Access Compliance Report

Public Rights-of-Way

(Curb Ramps)

Intersection ID: 22317	Main Street: SHARON_RD	Cross Street: SHARON_ACRES_RD	Location: E
ADA ID: AA5928FCACA6	Ramp Type: Perp	Initial Pass/Fail: Fail	Overall Compliance: No
Severity Score: 46.25			
Codes/Mitigation Info/Possible Solution		Field Measurements/Component Compliance

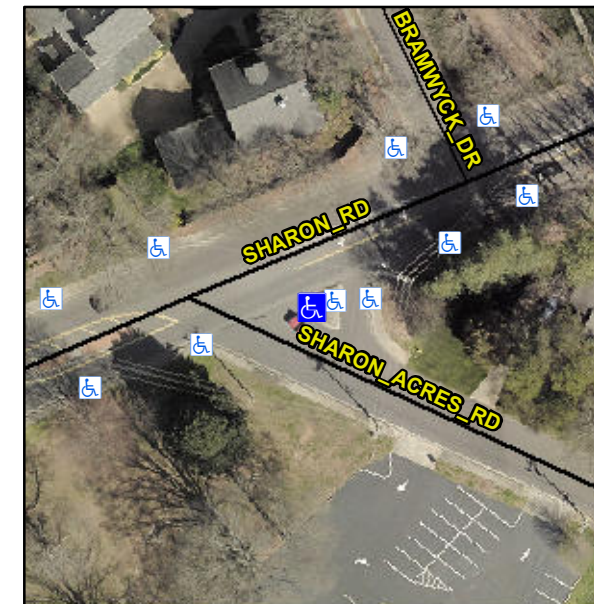
Not Found, R304.5.1, R304.2.2, R304.5.3

Compliance	Description	Data	Compliance	Description	Data
N/A	Ramp Length (in)	33.0	No	Ramp Slope (%)	10.2
No	Ramp Width (in)	40.0	No	Ramp XSlope (%)	8.2
N/A	Flare Type LT	N/A	N/A	Flare Type RT	N/A
N/A	Flare Slope LT (%)	N/A	N/A	Flare Slope RT (%)	N/A
N/A	Flare Traversable LT?	N/A	N/A	Flare Traversable RT?	N/A
N/A	Landing Length (in)	N/A	N/A	DWS Provided?	N/A
N/A	Landing Width (in)	N/A	N/A	DWS Contrast?	N/A
N/A	Landing Slope (%)	N/A	N/A	DWS Length (in)	N/A
N/A	Landing X Slope (%)	N/A	N/A	DWS Full Width?	N/A
N/A	Landing Curb? (Y/N)	N/A	N/A	DWS Offset (in)	N/A
N/A	Shared Landing?	N/A			
N/A	Gutter Ponding?	N/A	N/A	Gutter Slope (%)	N/A
N/A	Gutter Lip Ht (in)	N/A	N/A	Gutter X Slope (%)	N/A
N/A	Painted X Walk1?	No	N/A	Painted X Walk2?	N/A
	X Walk 1 Direction	To W		X Walk 2 Direction	N/A
N/A	X Walk 1 Width (in)	N/A	N/A	X Walk 2 Width (in)	N/A
	X Walk 1 Slope (%)	1.5		X Walk 2 Slope (%)	N/A
	X Walk 1 X Slope (%)	2.3		X Walk 2 X Slope (%)	N/A

Remove & Replace Entire Ramp.
